SUBJECT: Informs of review completion of inservice testing program documented in SSER 31. Further discussions required to clarify NRC evaluations of Items 3, 4 & 13 in Section 5.2.8.1. Meeting requested for 851104-05 in Bethesda, MD.

PGandE Letter No.: DCL-85-320

Re: Docket No. 50-275, OL-DPR-80
Docket No. 50-323, OL-DPR-82
Diablo Canyon Units 1 and 2
Inservice Testing Program

EMERGENCY CORE COOLING SYSTEM CHECK VALVES

FSAR UPDATE
UNIT 1
DIABLO CANYON SITE
 FIGURE 3.2-09 (Sheet 5 of 10)
 PIPING SCHEMATIC
 SAFETY INJECTION SYSTEM

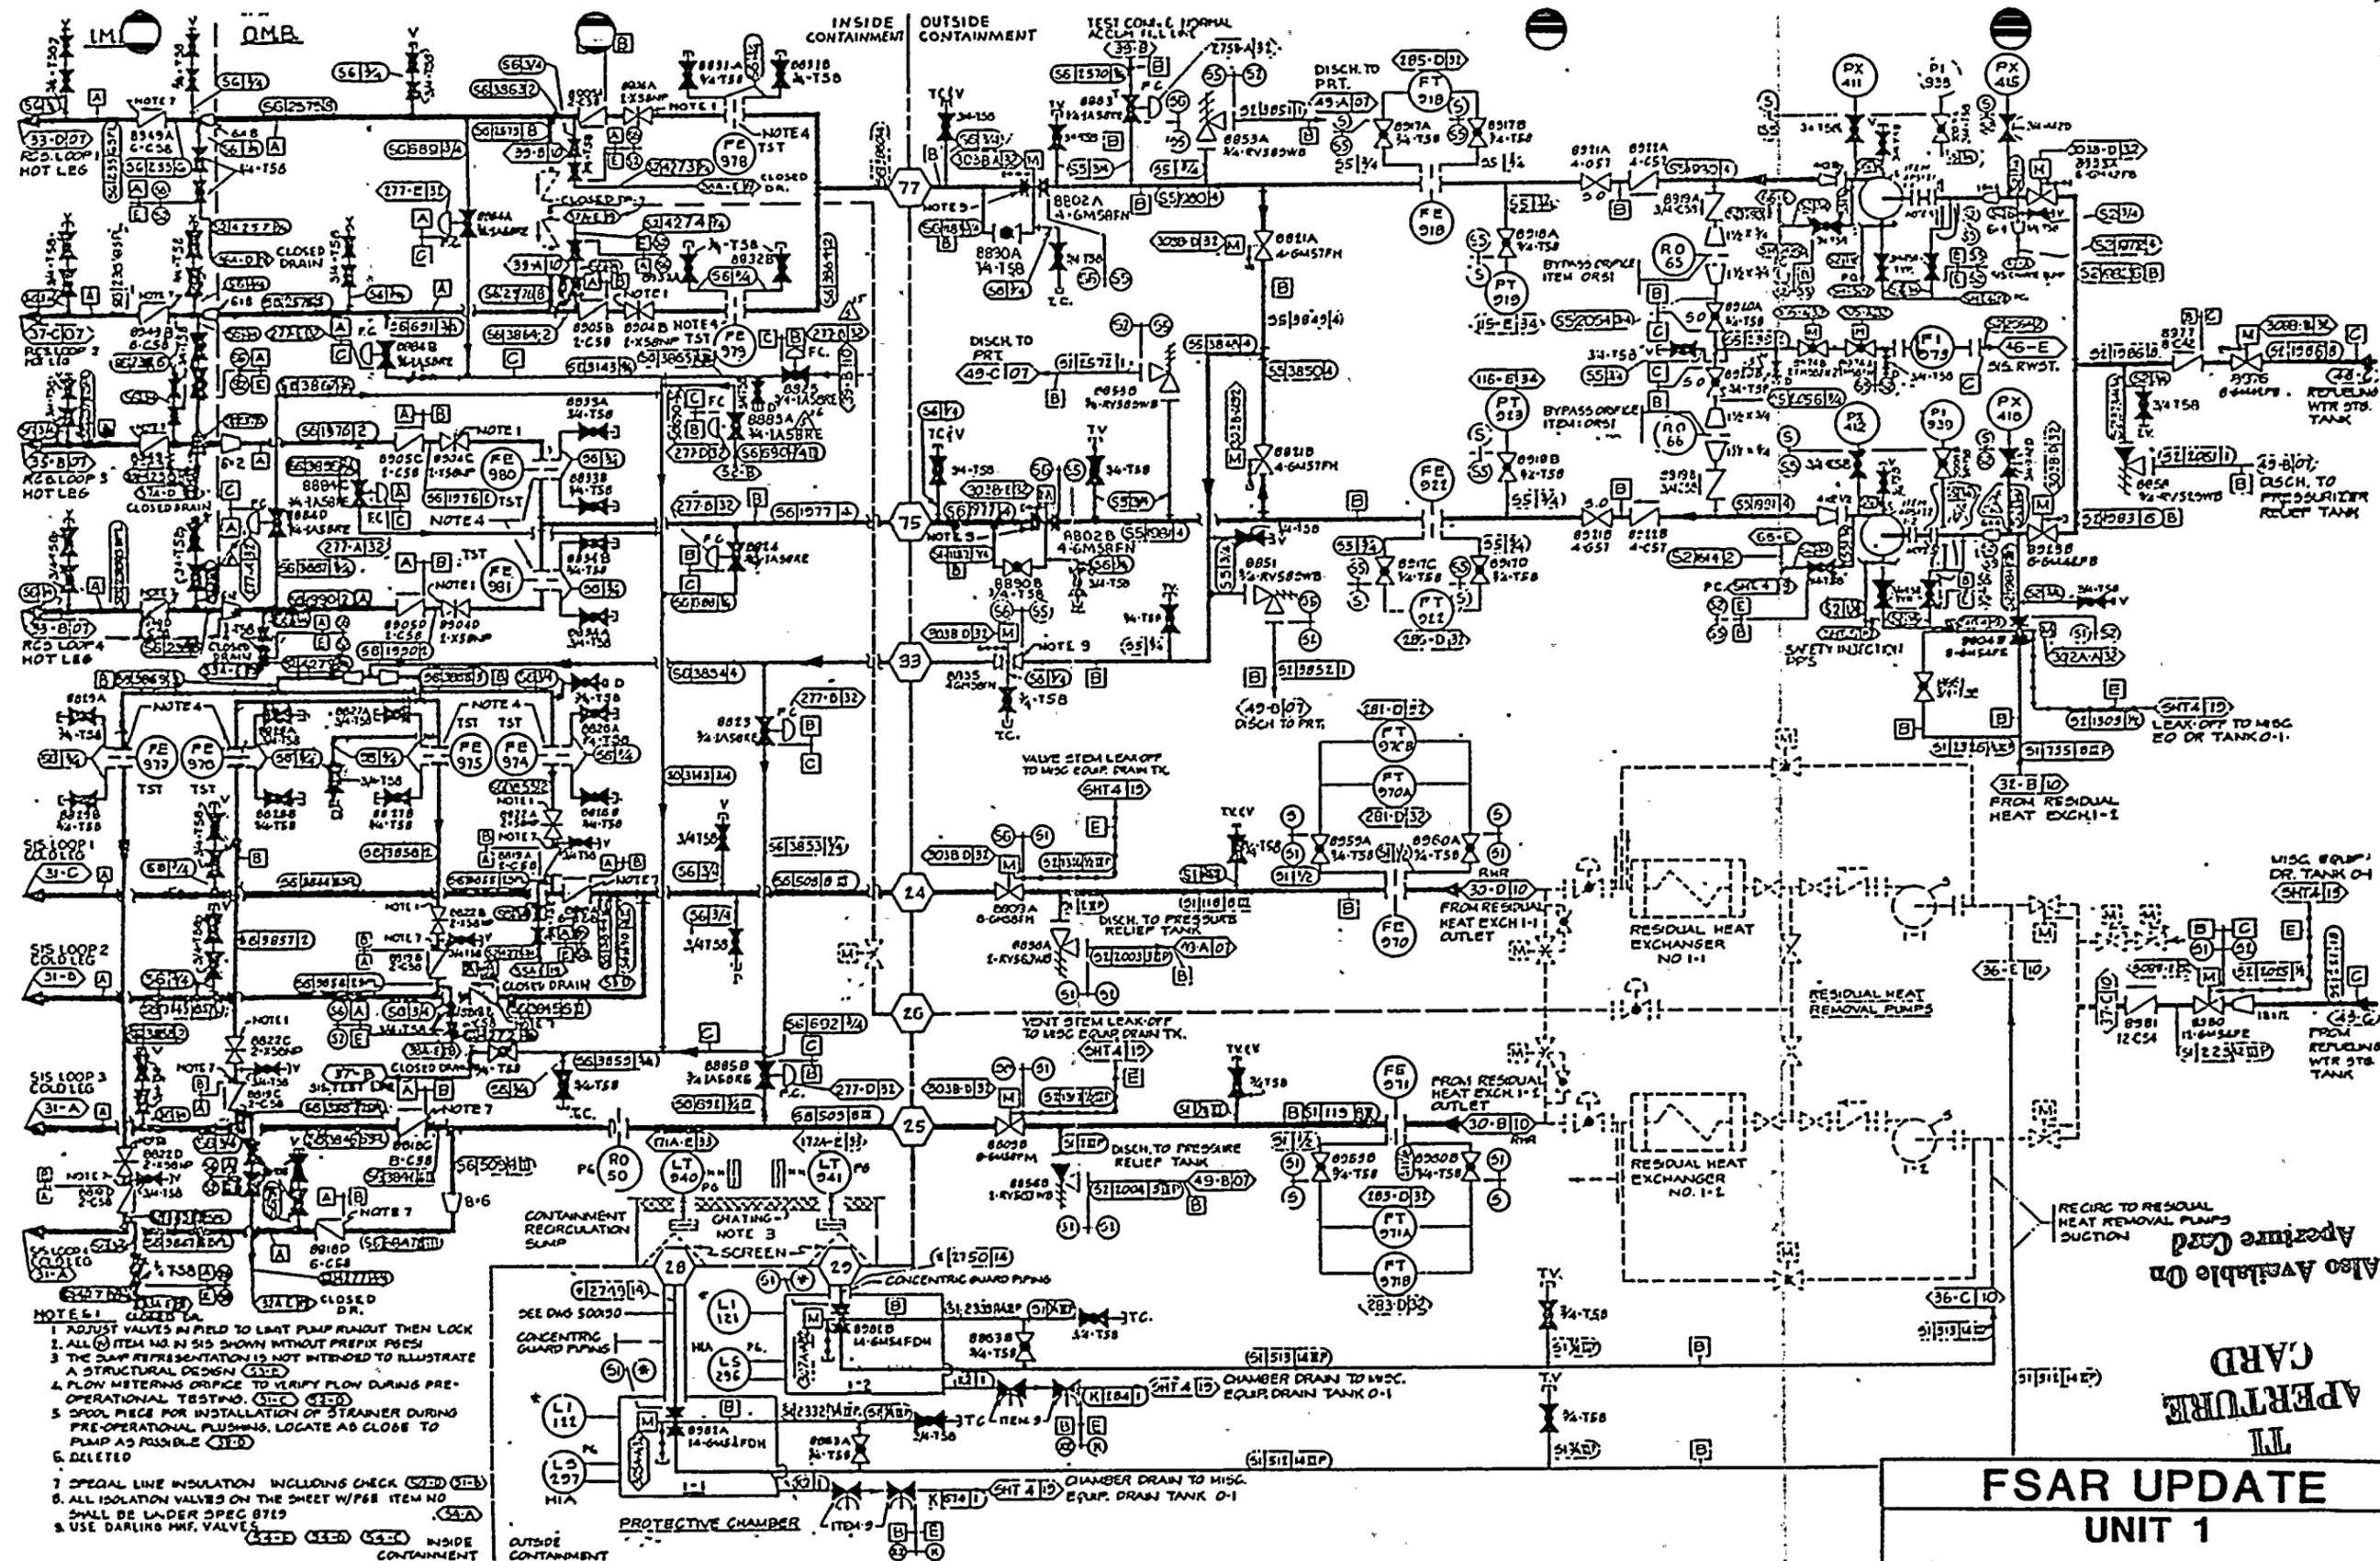
"PGandE has classified certain check valves in the safety injection system and the residual heat removal system, which perform a pressure boundary isolation function, as Category C valves. These systems, which are connected to the reactor coolant pressure boundary, have design pressures that are below the reactor coolant system operating pressure. The redundant isolation check valves are within the ASME Section III, Class 1 boundary forming an interface between the high and low pressure systems and protect the low pressure systems from pressures that exceed their design limit. In this role, the check valves perform a pressure isolation function. The staff considers the redundant isolation provided by these check valves to be an important safety function and therefore it is necessary to assure the condition of each check valve is adequate to maintain the redundant isolation capability.

Accordingly, the following check valves in the safety injection system and the residual heat removal system shall be reclassified valve category A/C and tested in accordance with Technical Specification 4.4.6.2.2 and included in Table 3.4-1 of the Technical Specifications. These check valves are:

8905A SI to hot leg-1, 8905B SI to hot leg-2,
8905C SI to hot leg-3, and 8905D SI to hot leg-4.

As clarified in discussions with the NRC Staff, the Diablo Canyon system design configuration shows that these check valves do not form an interface between high and low pressure systems. The attached FSAR Update figures provide the piping schematics for the safety injection system and the residual heat removal system. These schematics show that, in both cases, the upstream and downstream piping classification is S6, which is nominally rated at 2500 psia. The valves that form the interface between the high and low pressure systems are one valve further upstream in the systems' flow path, i.e., valves 8802A and B for the safety injection system and valve 8703 for the residual heat removal system.

During plant operation, routine performance of Technical Specification Surveillance Requirement 4.5.2 once per shift ensures that valves 8802A, 8802B, and 8703 are closed with the power to their valve operators removed. With power removed, inadvertant operation of these valves is not possible and accidental overpressurization of the safety injection and residual heat removal systems is prevented.

Since check valves 8905A, B, C and D and 8740A and B do not perform a pressure boundary isolation function, and administrative controls are in place to prevent overpressurization of the safety injection and residual heat removal systems, it is not necessary to reclassify these valves as Category A/C as stated in SSER 31. For the same reasons, these valves require neither testing in accordance with Technical Specification 4.4.6.2.2 nor inclusion into Table 3.4-1 of the Technical Specifications.

FIGURE 3.2-10 (Sheet 1 of 6)
 PIPING SCHEMATIC
 RESIDUAL HEAT REMOVAL SYSTEM

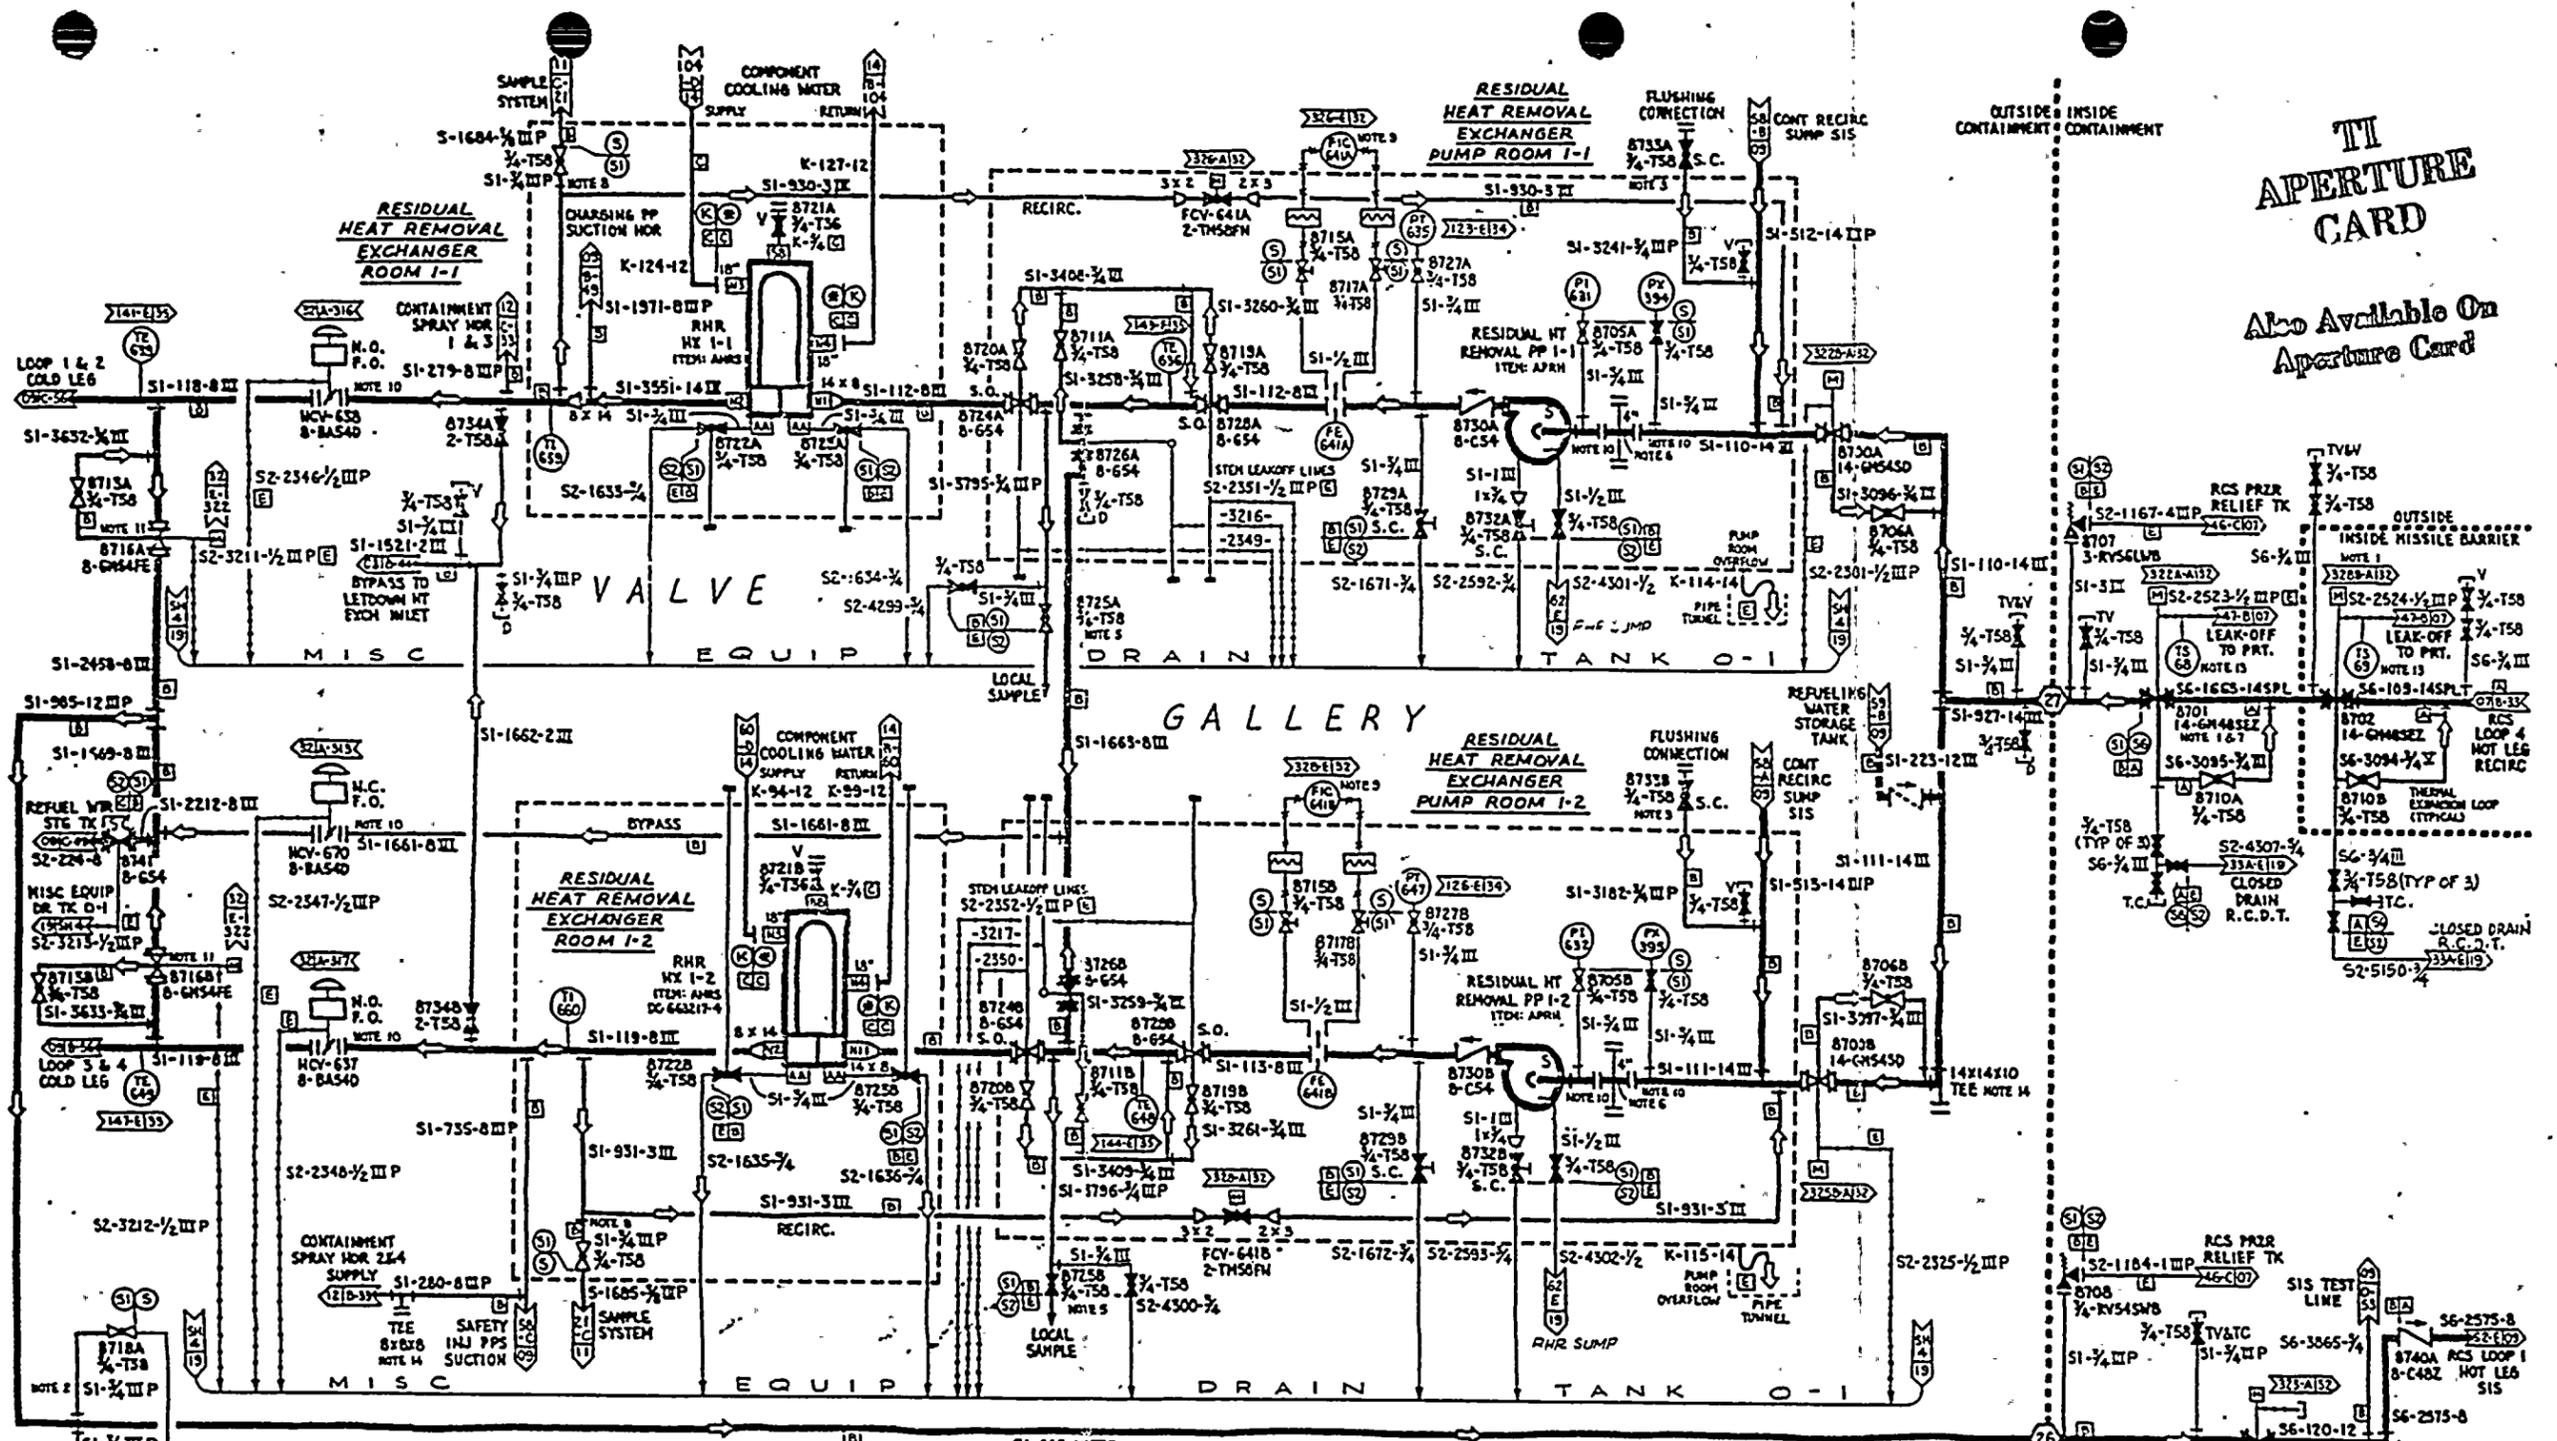
8740A RHR to hot leg-1, and 8740B RHR to hot leg-2."
